Windsor Bridge replacement project

Submissions report
Incorporating preferred infrastructure report

APRIL 2013

Figure 5-1 Change in height of bridge and approach road – southern bank

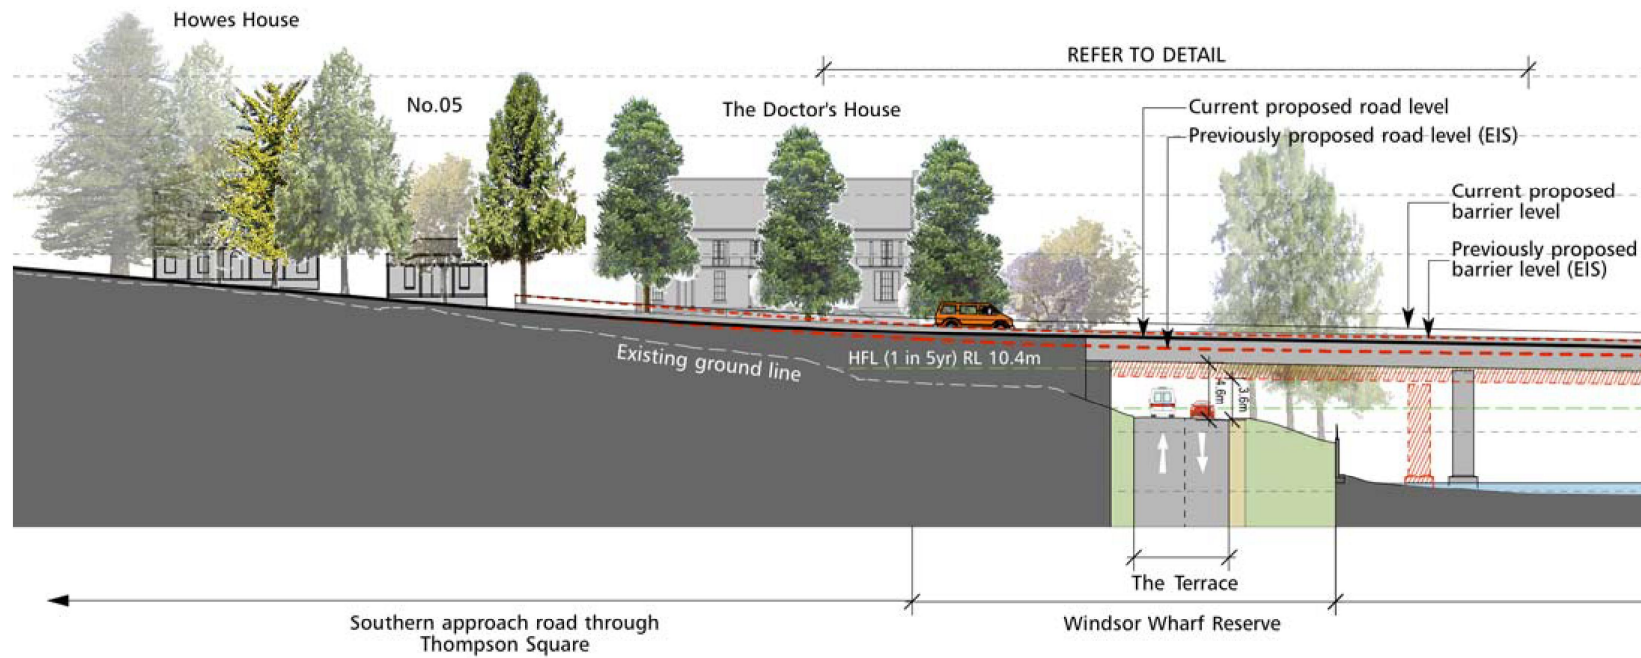
Figure 5-1 and **Figure 5-2** presents the difference in heights of the modified project in comparison to the project presented in the EIS.

Figure 5-3 Cross-section of double T bridge

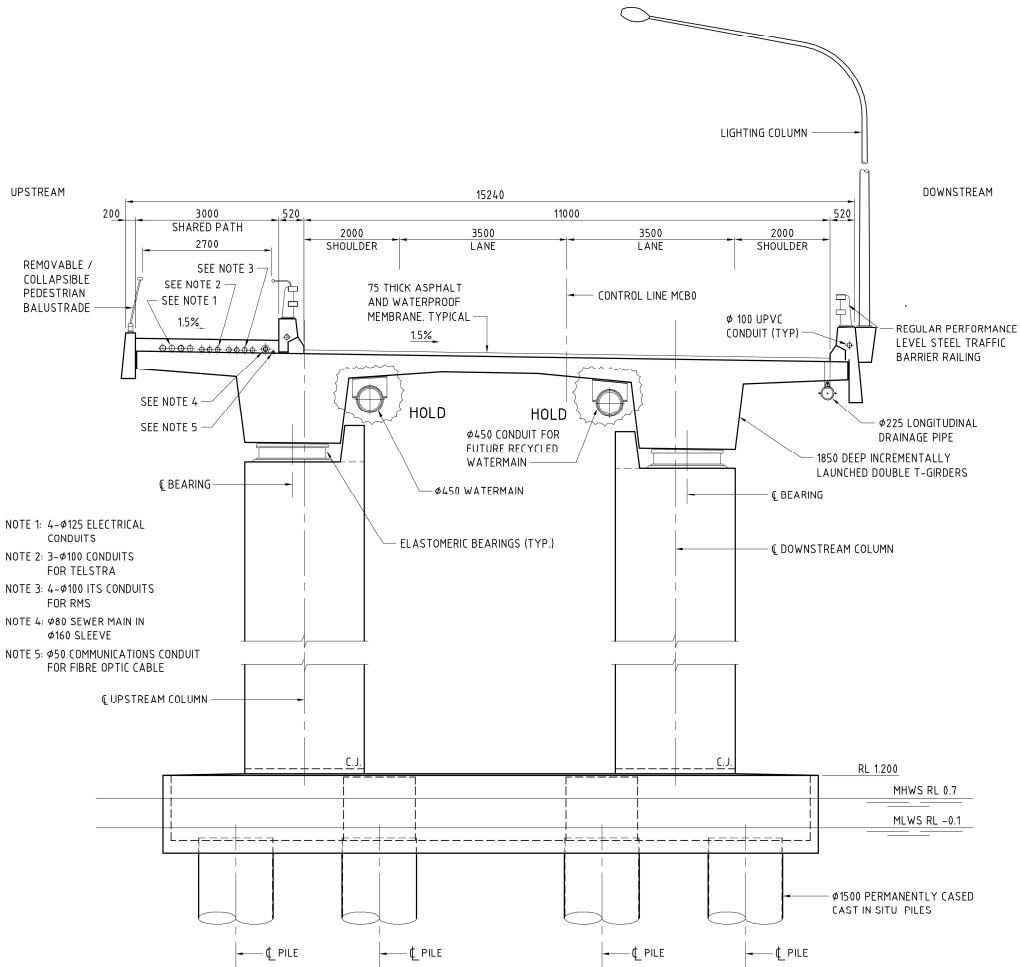
- Instead of a double box girder bridge as shown in Figure 5-4 of the EIS, a double T bridge would be constructed. A double T bridge would have a slightly shallower superstructure than a double box girder bridge but would otherwise have similar features to those described in the EIS. It would be incrementally launched as described in the EIS. **Figure 5-3** shows a cross section of the double T bridge.
- To accommodate the double T bridge, the location of the bridge piers in the Hawkesbury River would change slightly from those presented in the EIS. The changes in pier locations are presented in **Figure 5-4**. The southern and northern piers closest to the respective river banks would be located further from the banks and there would be a minor change in location for one of the central piers.

Figure 5-4 Changed pier locations – Note grey indicates original pier location and black indicates new pier location

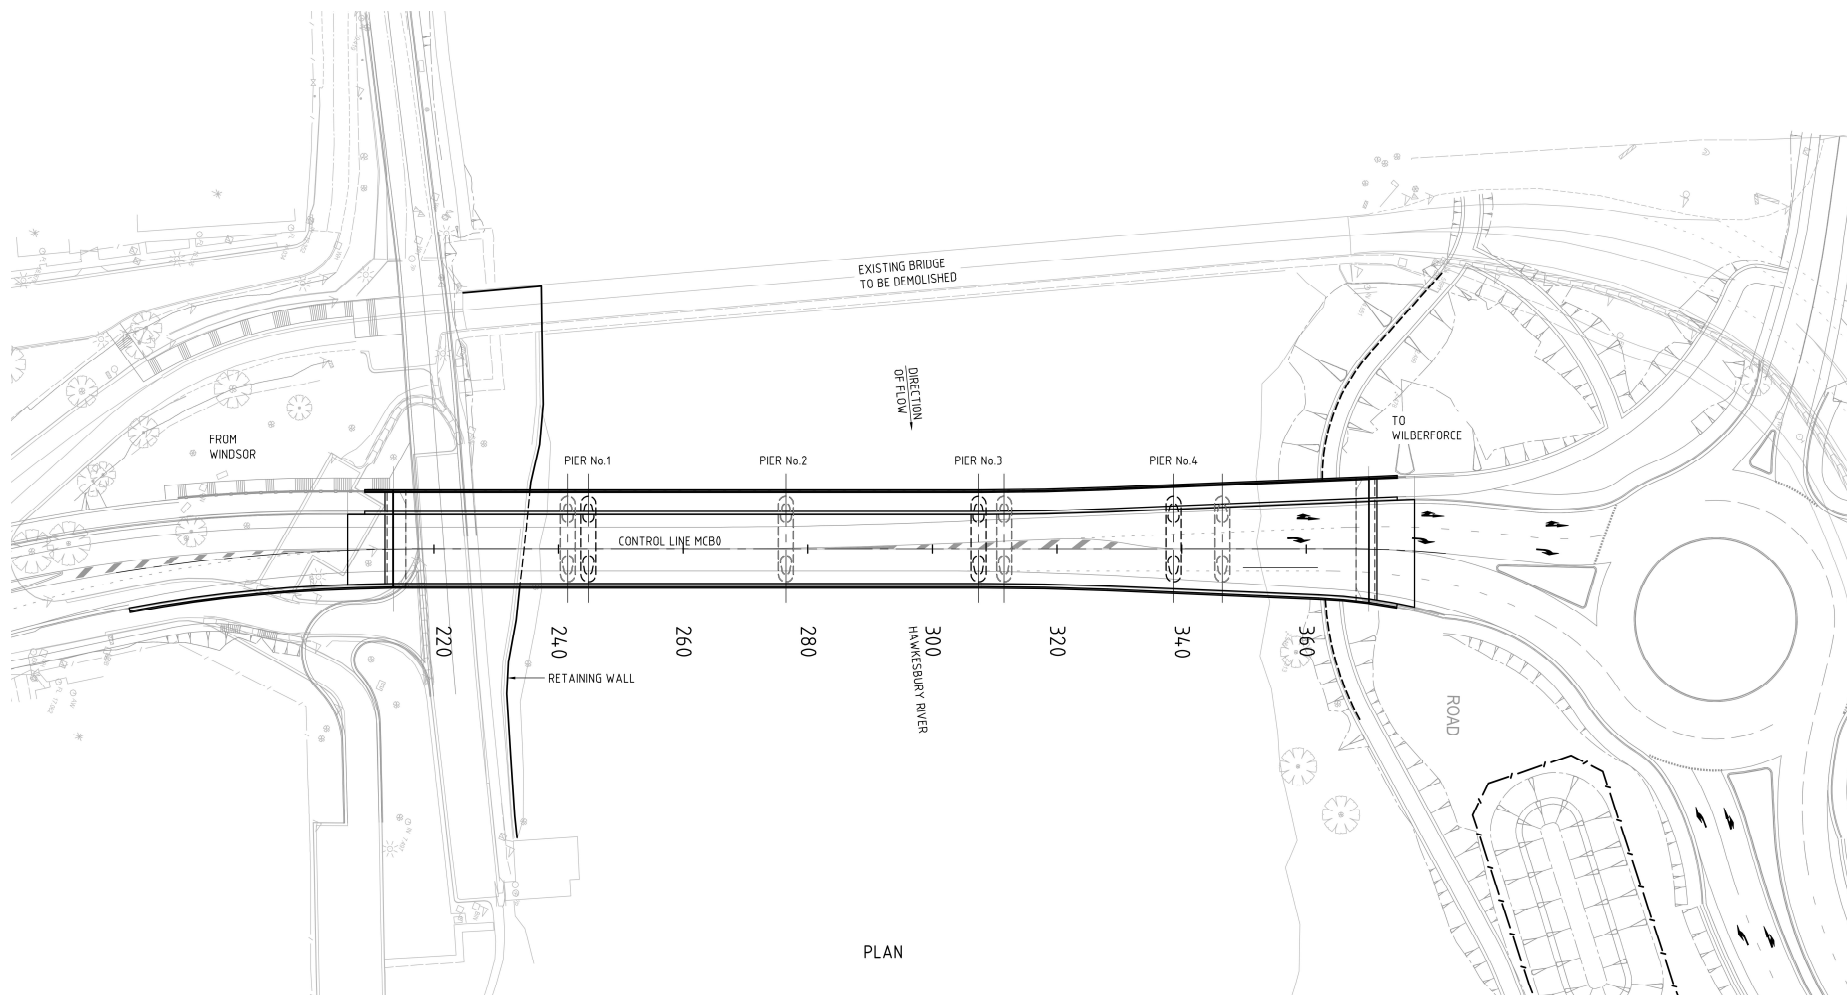
The change in the location of the bridge pier closest to the southern river bank would result in a minor reduction in direct impacts on maritime archaeological remains and may reduce the scour of the southern bank during flood events. Additionally, the proposed location and spacing of the piers away from the river bank, combined with the proposed increase in the clearance of the bridge over The Terrace, would enhance the perception of space along the foreshore and under the bridge and open up the views from The Terrace. This is explained further in the Landscape Character and Visual Impact Assessment Addendum in **Appendix D**.

Figure 1.1: Proposed changes to the project. The previous design presented in the EIS is shown in red.

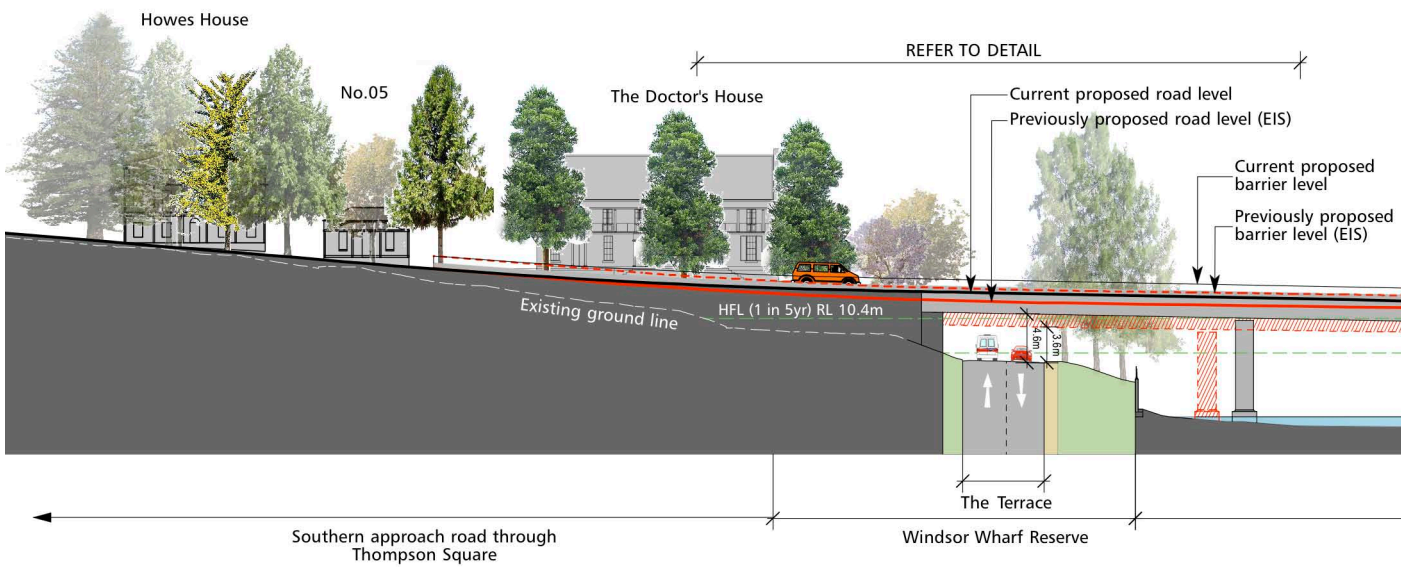
The location of the piers would be slightly changed so that they are evenly spaced across the river, supporting equal spans of 31.32 metres along the length of the bridge. The proposed location of the piers are also shown in Figure 1.1. No changes to the abutments are proposed.

Figure 1.2: Detail section at The Terrace.

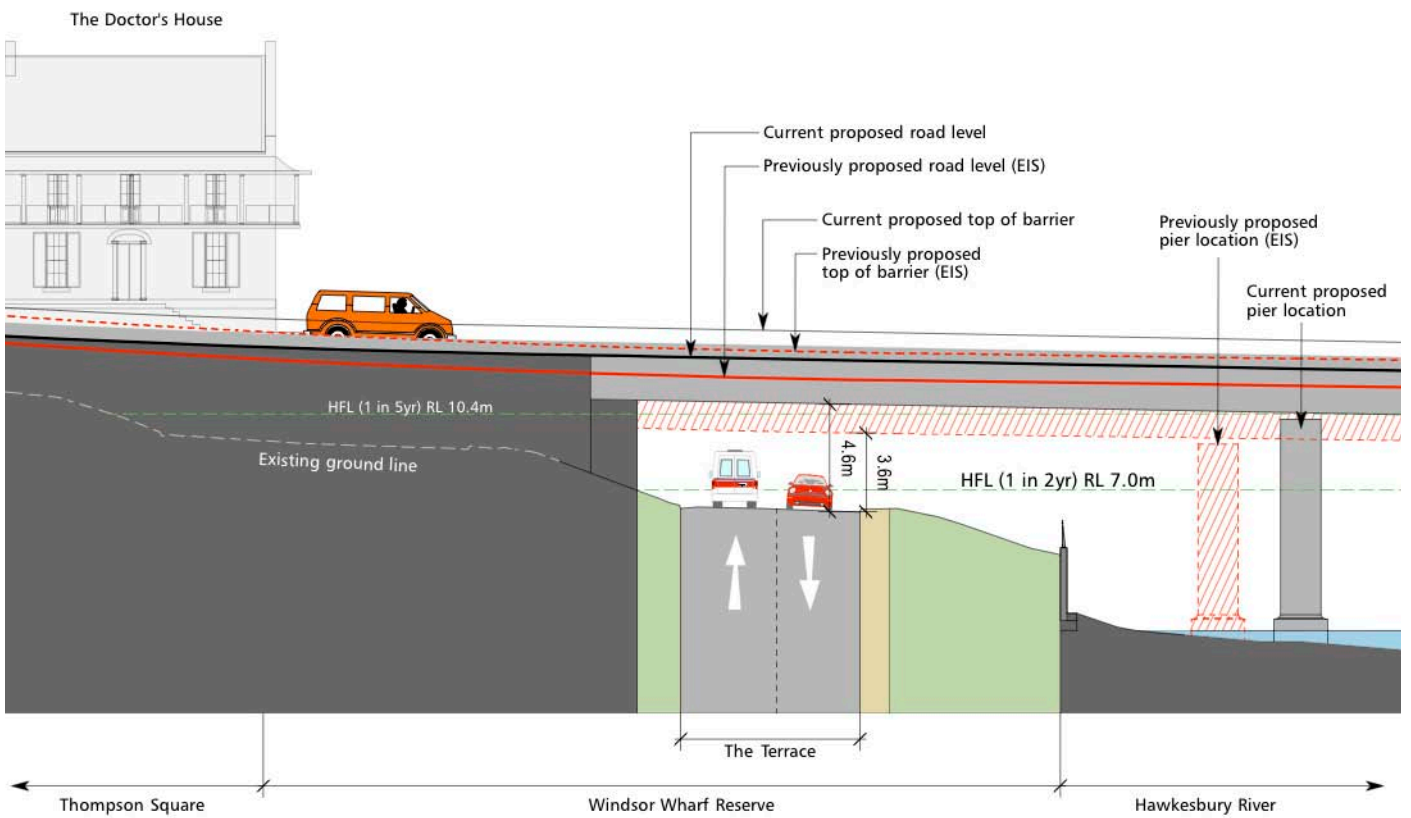
Figure 1.1 and Figure 1.2 presents the difference in heights of the modified project in comparison to the project presented in the EIS.
